Re: Second Submission Review – Forum Vista Creek – Master Plan, Site Plan and Final Plat
Application Number: **DA-2248-01**
Case Numbers: **2021-7009-00; 2021-4025-00; 2021-3051-00**

Second Submission Review

4 BUILDING A - WEST ELEVATION

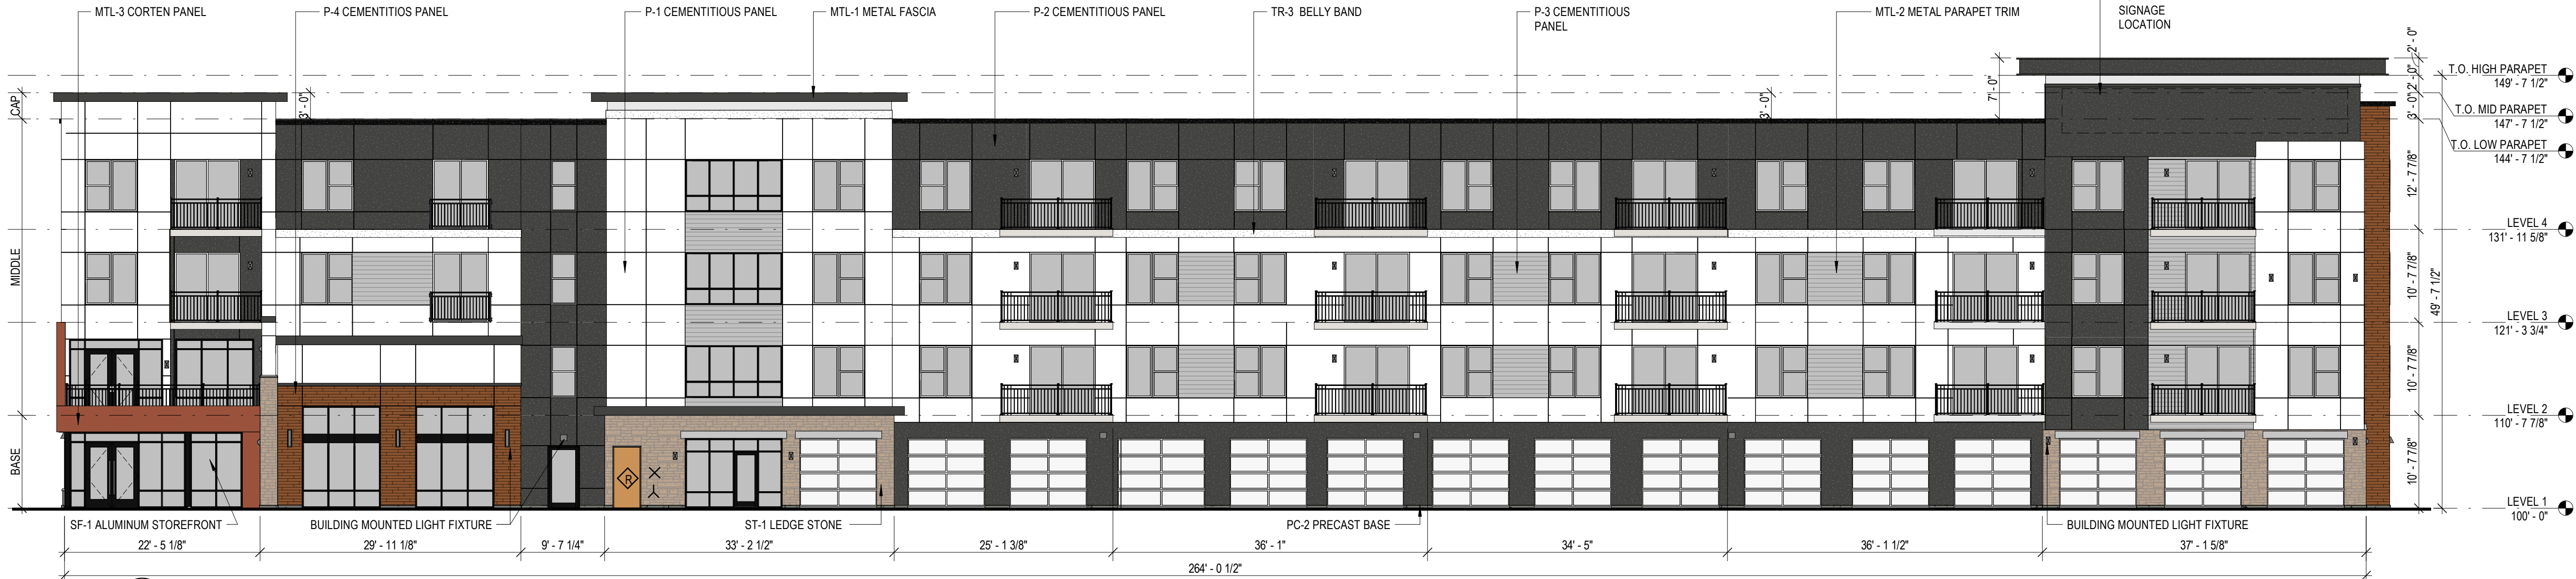
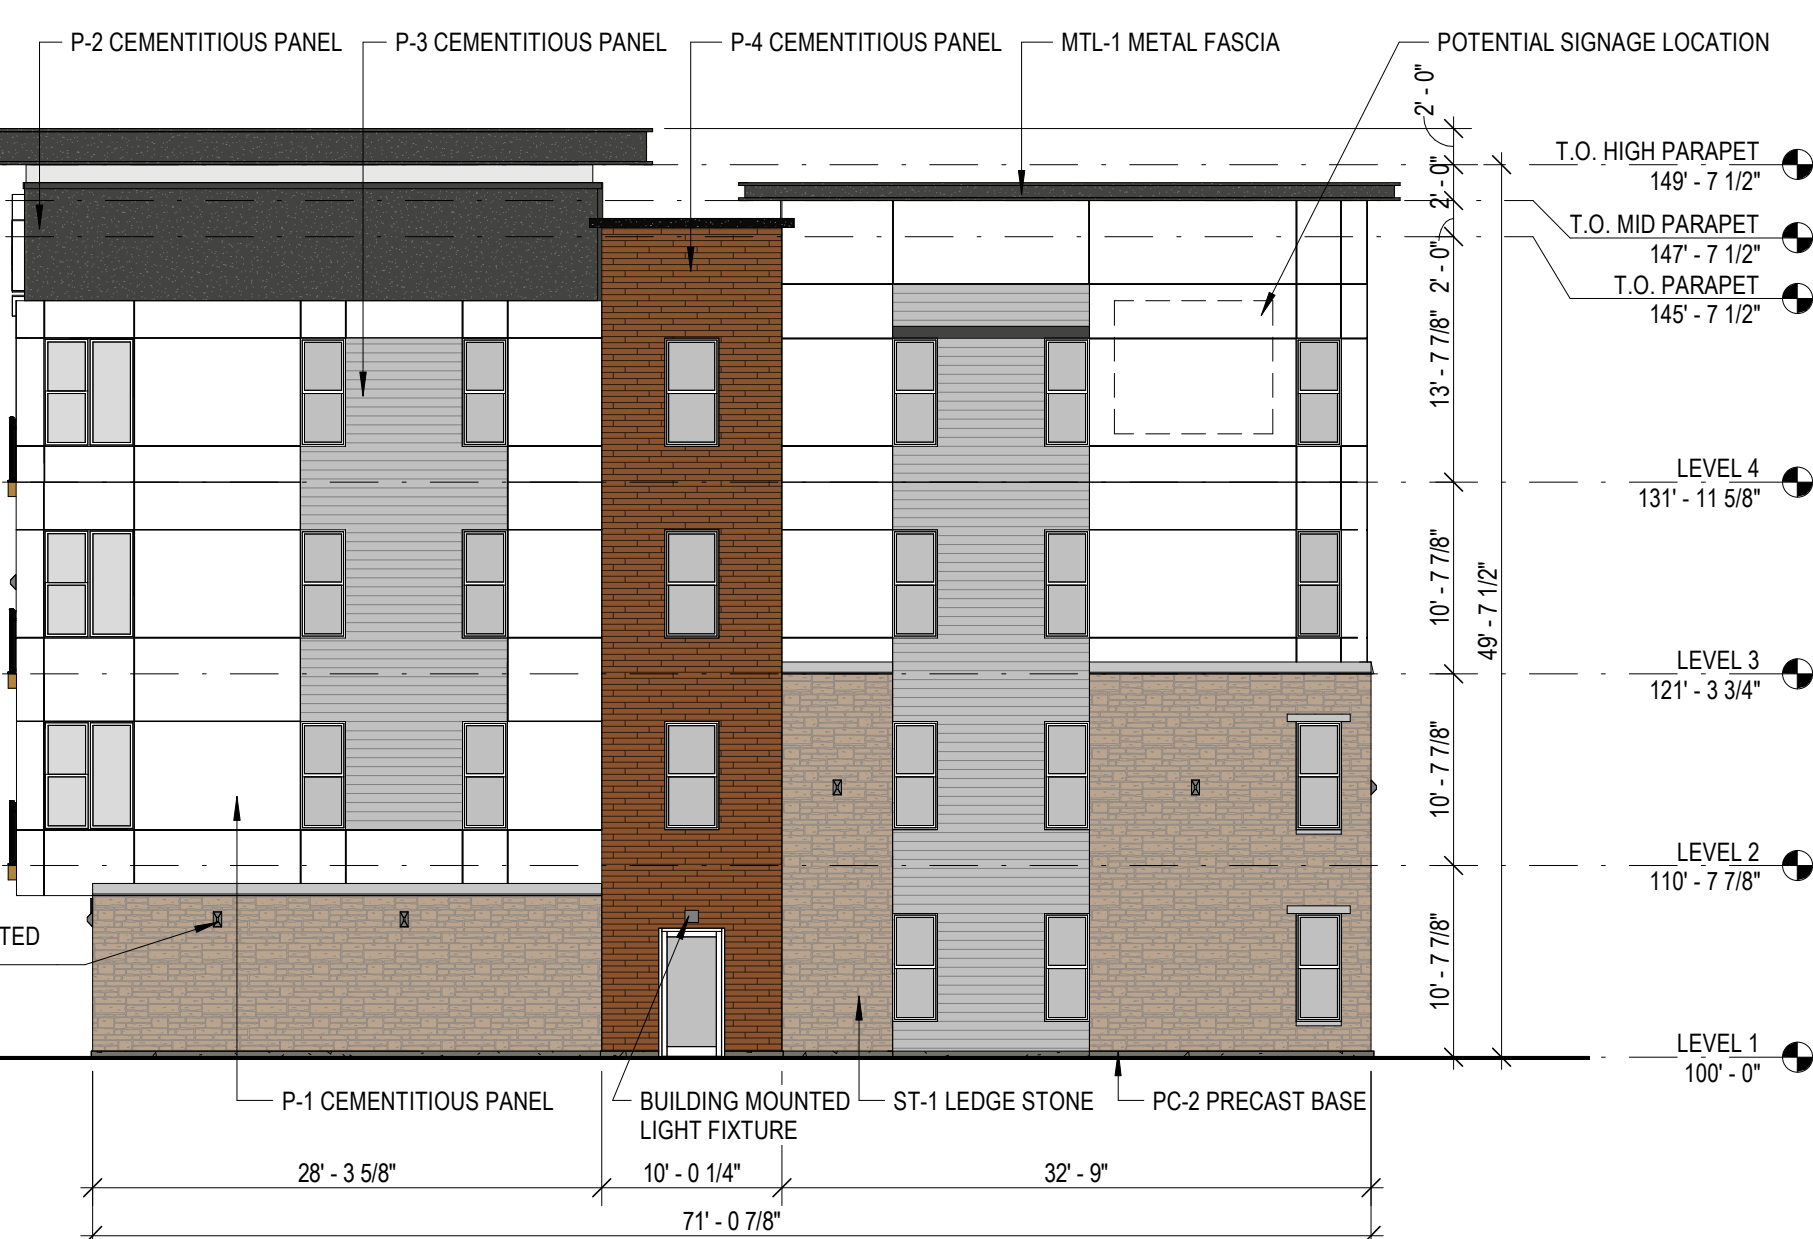
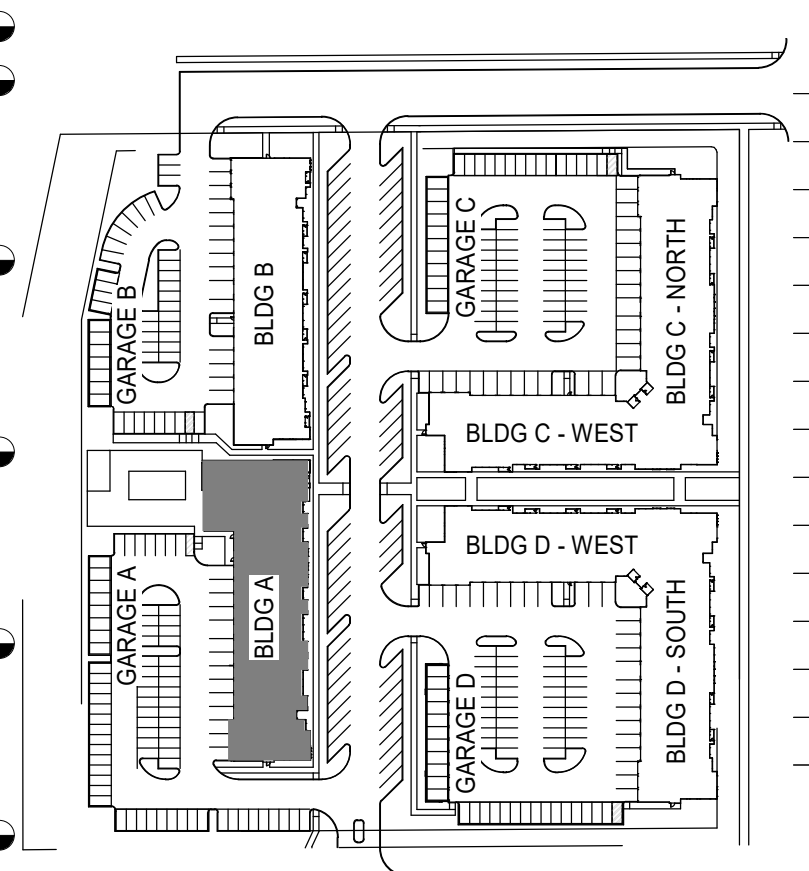
Remove potential, typical. The wall signage location must be shown on these elevations. If it changes in the future, we would require a mylar change to update accordingly.

Removed and a dashed area was added to indicate a sign will be placed here

SHEET TITLE:
BUILDING D -
ELEVATIONS

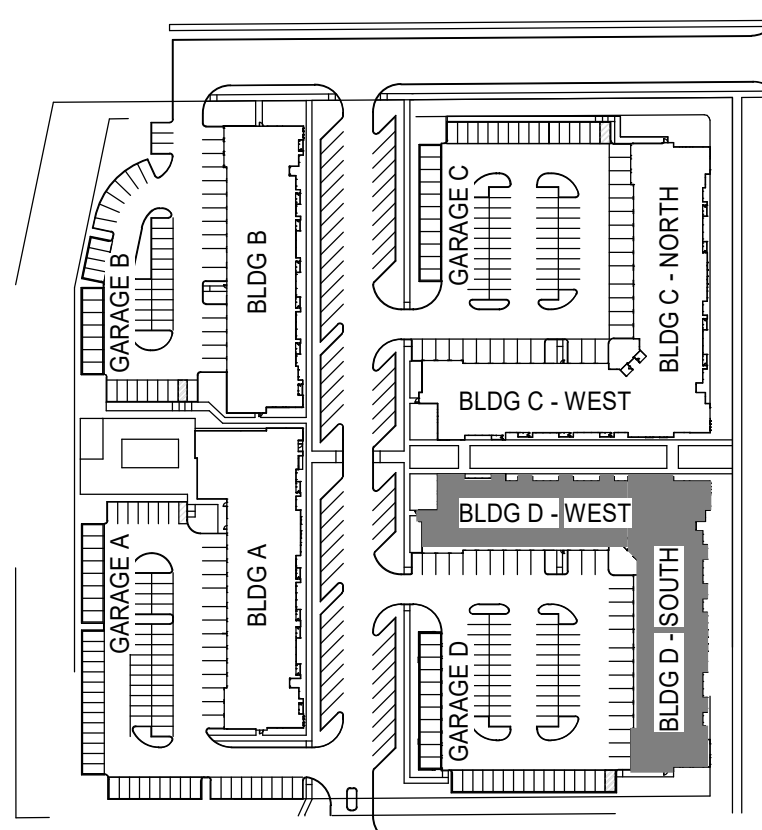
Building D please show the location of the FDC, Knox Boxes & Riser Room Door on Elevation Sheets.

- Identify the FDC as a Y symbol and label with the following example: "FDC with approved Knox Caps."
- Identify the Knox Box as an X within a box symbol and label with the following example: "Knox Box with approved hardware."
- Identify the Riser Room Door and label: Rise Room Door.

The location of the FDC, Knox Boxes & Riser Room Door on building D, has been annotated with the requested symbols. For labels / identification each building elevations sheets have a reference legend.

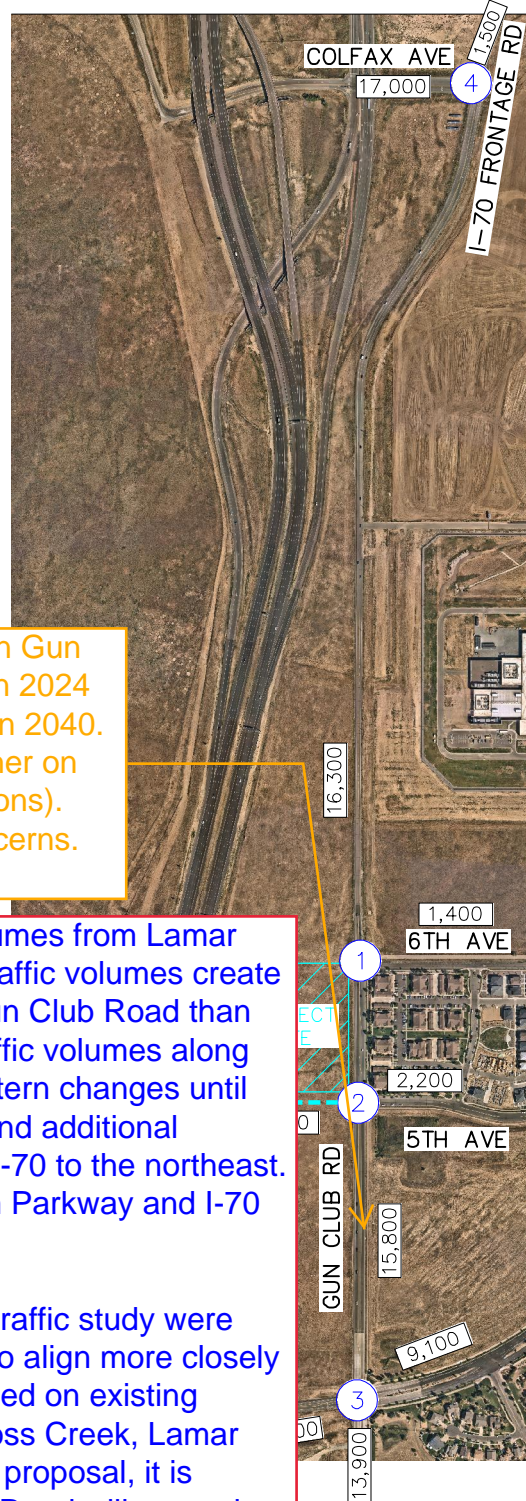
Both volumes shown on Gun Club Road are higher in 2024 than NEATS plans for in 2040. Numbers are even higher on Figure 6 (2045 projections). See comments for concerns.

Traffic volumes from the Aurora Crossroads traffic study were used as background traffic volumes in 2045 to align more closely to traffic projections in the NEATS study. Based on existing volumes and future development of FDP, Cross Creek, Lamar Landing, Aurora Crossroads, and the current proposal, it is believed that traffic volumes along Gun Club Road will exceed the projections in the NEATS study. However, the traffic volumes along Gun Club Road in the revised traffic study no longer double the NEATS projections. It is agreed that travel patterns will shift with the future extension of 6th Parkway to the east and additional interchange access to I-70 to the northeast. However, it is believed that using the traffic volumes from the Aurora Crossroads study as background traffic is appropriate as this provides a conservative analysis, whereas, reducing traffic volumes along Gun Club Road in 2045 to be less than the 2024 horizon does not seem appropriate.

FIGURE 8

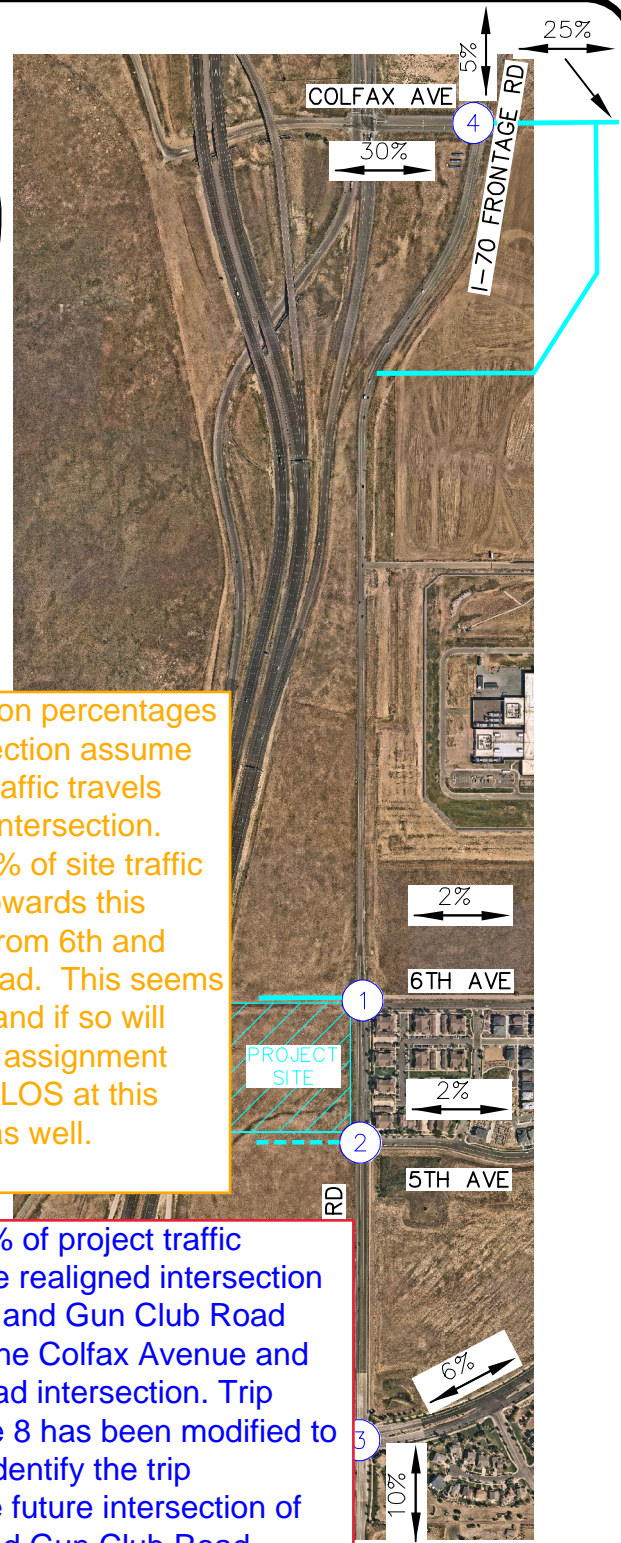
c) A possible error in Trip Distribution percentages in Figure 8 which would influence trip assignment and LOS.

The distribution percentages at this intersection assume 35% of site traffic travels through this intersection. However, 60% of site traffic is traveling towards this intersection from 6th and Gun Club Road. This seems like an error and if so will influence trip assignment and possibly LOS at this intersection as well.

This is due to 25% of project traffic utilizing the future realigned intersection of Colfax Avenue and Gun Club Road while bypassing the Colfax Avenue and I-70 Frontage Road intersection. Trip distribution Figure 8 has been modified to more effectively identify the trip distribution on the future intersection of Colfax Avenue and Gun Club Road.

This is due to 25% of project traffic utilizing the future realigned intersection of Colfax Avenue and Gun Club Road while bypassing the Colfax Avenue and I-70 Frontage Road intersection. Trip distribution Figure 8 has been modified to more effectively identify the trip distribution on the future intersection of Colfax Avenue and Gun Club Road.

FIGURE 14

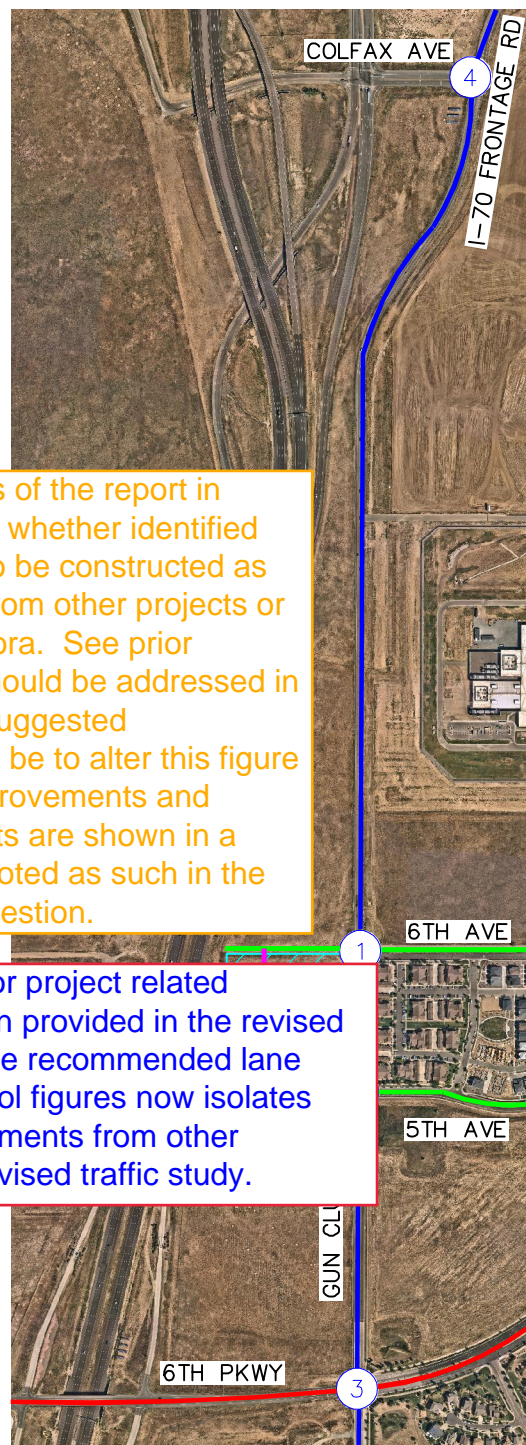
There remain pieces of the report in which it is confusing whether identified improvements are to be constructed as part of the project, from other projects or from the City of Aurora. See prior comments. They should be addressed in those areas, but a suggested enhancement would be to alter this figure so that "project" improvements and "other" improvements are shown in a different color and noted as such in the legend. Just a suggestion.

Additional discussion for project related improvements has been provided in the revised traffic study. Further, the recommended lane configuration and control figures now isolates project related improvements from other improvements in the revised traffic study.
